Draft Railway Order 2022

Book 1 of 1

Item No.	Description of Change	Drawing Number	Draw	ing Title	Details of Change(s) Made to Drawing
1		ML1-JAI-ARD-ROUT_XX-DR-Y-01018	METROLINK - ALIGNMENT	LONG SECTION 18	Alignment long section showing proposed lowered alignment between St Stephen's Green and Charlemont.
2	7524	ML1-JAI-ARD-ROUT_XX-DR-Y-01019	METROLINK - ALIGNMENT	LONG SECTION 19	Alignment long section showing proposed lowered alignment between St Stephen's Green and Charlemont.
3	St. Stephen's Green Station to Charlemont Station - Tunnel vertical	ML1-JAI-ARD-ROUT_XX-DR-Y-03094	METROLINK - GENERAL ARRANGEMENT	ST. STEPHEN'S GREEN TO HATCH ST LOWER	Addition of new underground pumping station and lowering of tunnel in Section A-A to reflect lowered alignment between St Stephen's Green and Charlemont stations.
4	alignment change	ML1-JAI-ARD-ROUT_XX-DR-Y-03095	METROLINK - GENERAL ARRANGEMENT	HATCH STREET LOWER TO GRANDE PARADE	Addition of new underground pumping station and lowering of tunnel in Section A-A to reflect lowered alignment between St Stephen's Green and Charlemont stations.

MATER STATION - LONGITUDINAL SECTION

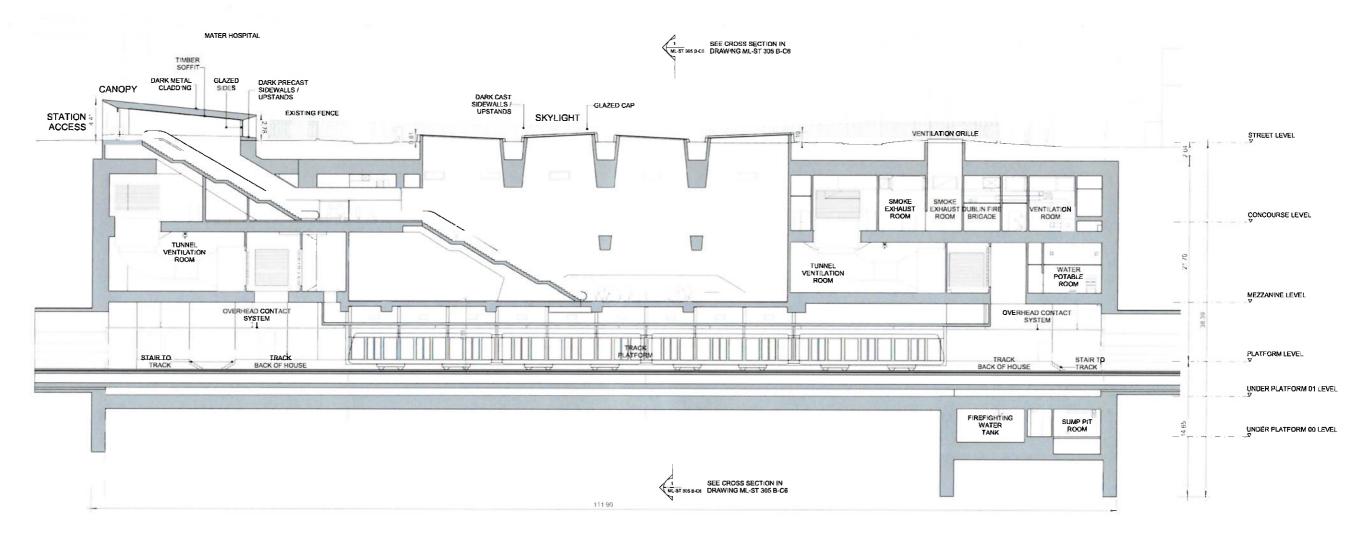
55		ML1-JAI-SRD-ROUT_XX-DR-Y-02066	MATER STATION	STREET LEVEL ELEVATION	Street level elevation showing skylights reduced in height.
56	Mater Station - Skylight height reduced to between 1.1m and 0.8m above ground level.	ML1-JAI-SRD-ROUT_XX-DR-Y-02069	MATER STATION	LONGITUDINAL SECTION	Longitudinal section showing skylights reduced in height.
57		ML1-JAI-SRD-ROUT_XX-DR-Y-02070	MATER STATION	CROSS SECTION	Cross section showing skylights reduced in height.

Drawing N° ML1-JAI-SRD-ROUT_XX-DR-Y-02070

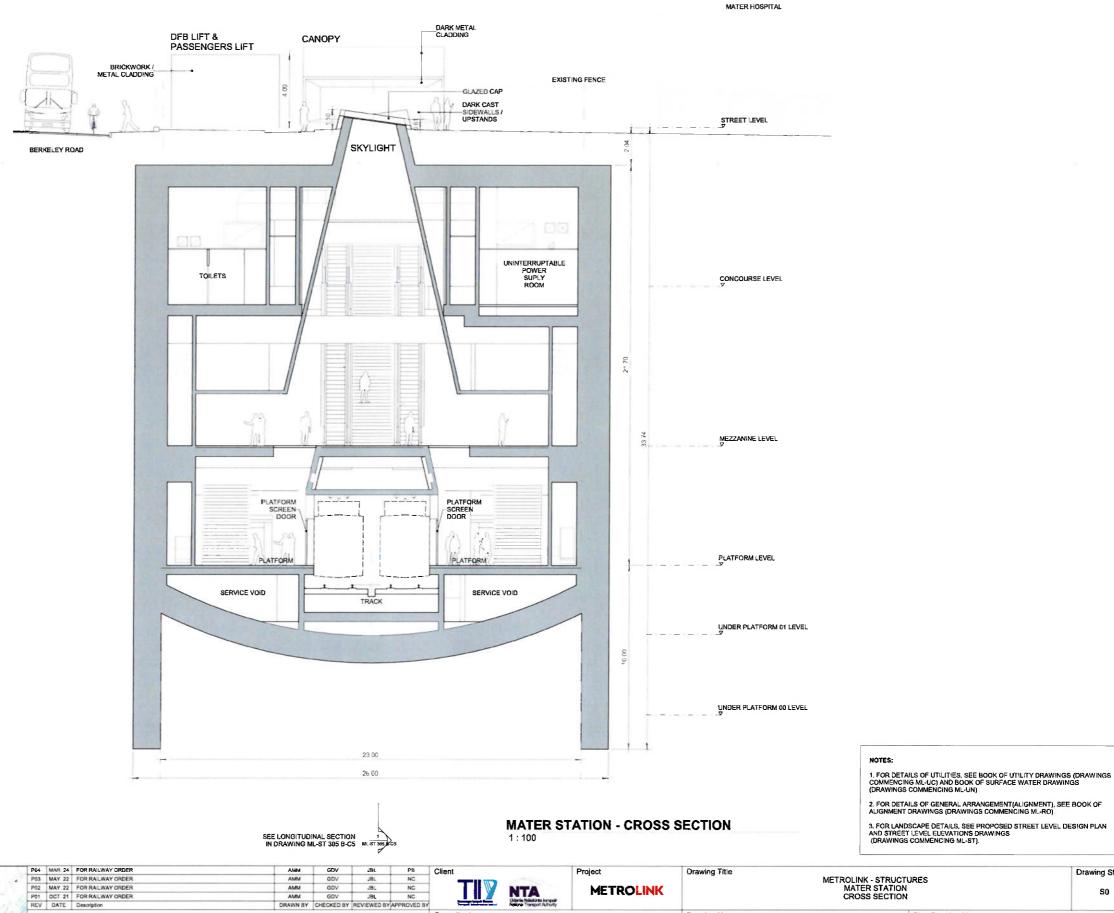
Drawing Number		Drawing Title	Details of Change(s) Made to Drawing
ML1-JAI-SRD-ROUT_XX-DR-Y-02069	MATER STATION	LONGITUDINAL SECTION	Longitudinal section showing skylights reduced in height.
ML1-JAI-SRD-ROUT_XX-DR-Y-02070	MATER STATION	CROSS SECTION	Cross section showing skylights reduced in height.
ML1-JAI-SRD-ROUT_XX-DR-Y-02071	O'CONNELL STREET STATION	PROPOSED STREET LEVEL DESIGN	Drawing plotting error rectified to show footprint of station and drawing updated to reflect trees on O'Connell Street will be retained.
ML1-JAI-SRD-ROUT_XX-DR-Y-02072	O'CONNELL STREET STATION	STRUCTURES STREET LEVEL	O'Connell Street Station entrance updated to reflect architectural intent.
ML1-JAI-SRD-ROUT_XX-DR-Y-09017	O'CONNELL STREET STATION	STRUCTURES STREET LEVEL	New street level elevation drawing to reflect a no over site development scenario.
ML1-JAI-SRD-ROUT_XX-DR-Y-02078	TARA STREET STATION	STRUCTURES STREET LEVEL	Street level design drawing changed from 3 No. to 5 No. skylights with updated landscape layout.

Drawing N° ML1-JAI-SRD-ROUT_XX-DR-Y-02082

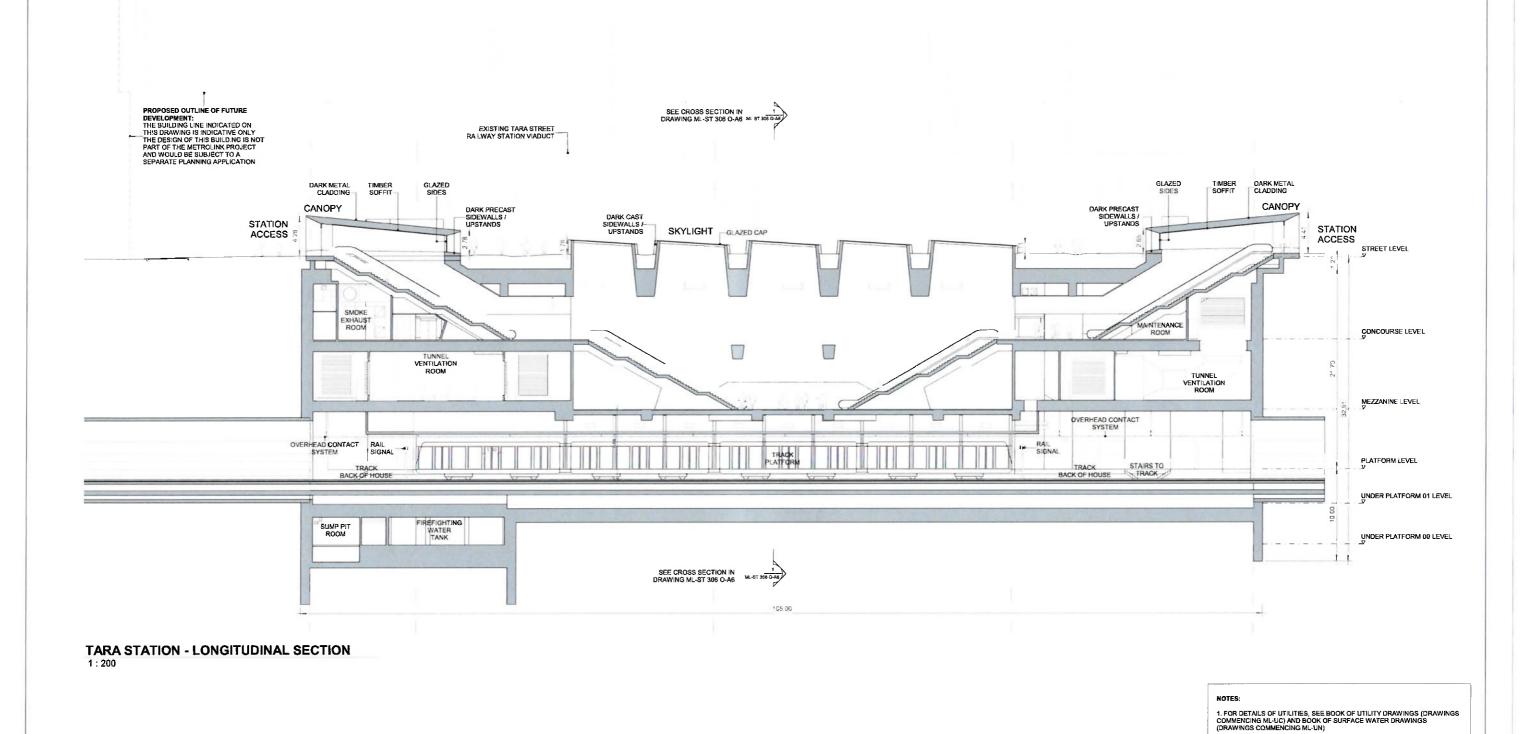
ML1-JAI-SRD-ROUT_XX-DR-Y-02082	TARA STREET STATION	LONGITUDINAL SECTION	Longitudinal section drawing changed from 3 No. to 5 No. skylights.
ML1-JAI-SRD-ROUT_XX-DR-Y-02084	ST. STEPHENS GREEN STATION	PROPOSED STREET LEVEL DESIGN	Street Level design drawing showing previously omitted part of Famine Memorial layout added to drawing and layout of HVM bollards revised.
ML1-JAI-SRD-ROUT_XX-DR-Y-02085	ST. STEPHENS GREEN STATION	STREET LEVEL ELEVATION	Street level elevation showing revised layout of HVM bollards.
ML1-JAI-SRD-ROUT_XX-DR-Z-02090	CHARLEMONT STATION	PROPOSED STREET LEVEL DESIGN	General arrangement showing parking layout on internal access road connecting Dartmouth Road and Grand Parade revised to 14 spaces (including two PRM) and drop-off and footway on Grand Parade widened.
ML1-JAI-URD-ROUT_XX-DR-Y-01011	METROLINK - UTILITY DIVERSION	BALHEARY DEMESNE (SHEET 5 OF 5)	Utilities drawing incorporating the extended cut and cover tunnel that replaces the previous section of open retained cut at Seatown Villas.

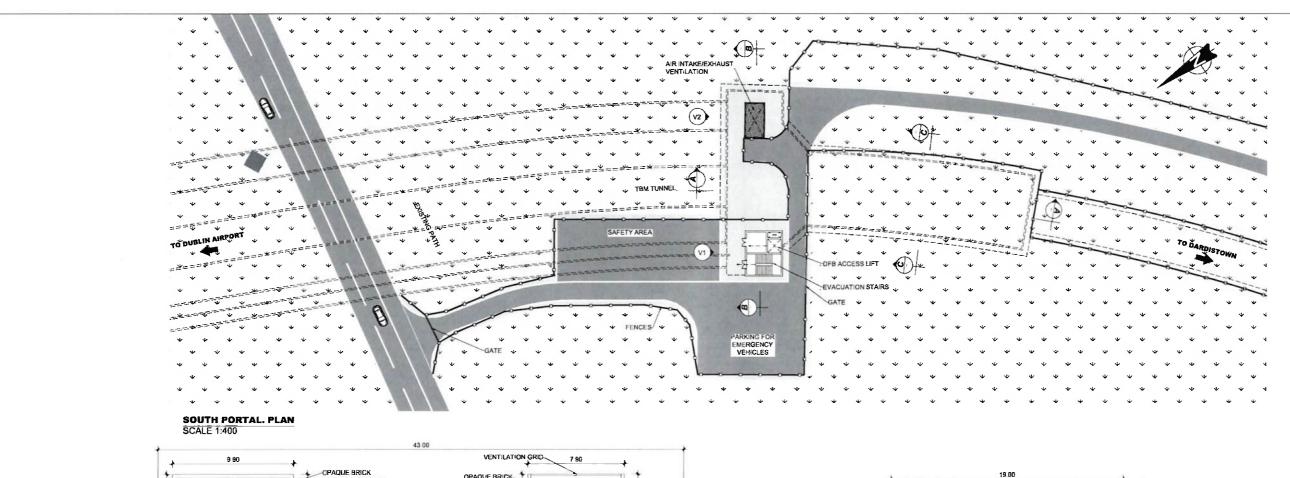
28	changed to reflect proposed TBM construction methodology.	ML1-JAI-SRD-ROUT_XX-DR-Y-01002	METROLINK - STRUCTURES SOUTH PORTAL	GENERAL ARRANGEMENT	Ventilation tunnel cross-section changed to a circular profile reflecting proposed TBM construction methodology.
29		ML1-JAI-SRD-ROUT_XX-DR-Y-01003	METROLINK - STRUCTURES SOUTH PORTAL VENTILATION AND EMERGENCY ACCESS	GENERAL ARRANGEMENT	Ventilation tunnel and emergency exit tunnel cross-section changed to a circular profile reflecting proposed TBM construction methodology.
30		ML1-JAI-ARD-ROUT_XX-DR-Y-03056	METROLINK - GENERAL ARRANGEMENT	OLD BALLYMUN ROAD (NORTH)	General arrangement drawing showing amendments of entrance to Santry Lodge arising from agreement with FCC.
31	Santry Lodge - amendments to Santry Lodge entrance arising from agreement with Fingal County Council.	ML1-JAI-ARL-SC07_GF-DR-X-00113	LANDSCAPE LAYOUT	NORTHWOOD - BALLYMUN	Landscape drawing showing amendments of entrance to Santry Lodge arising from agreement with FCC.
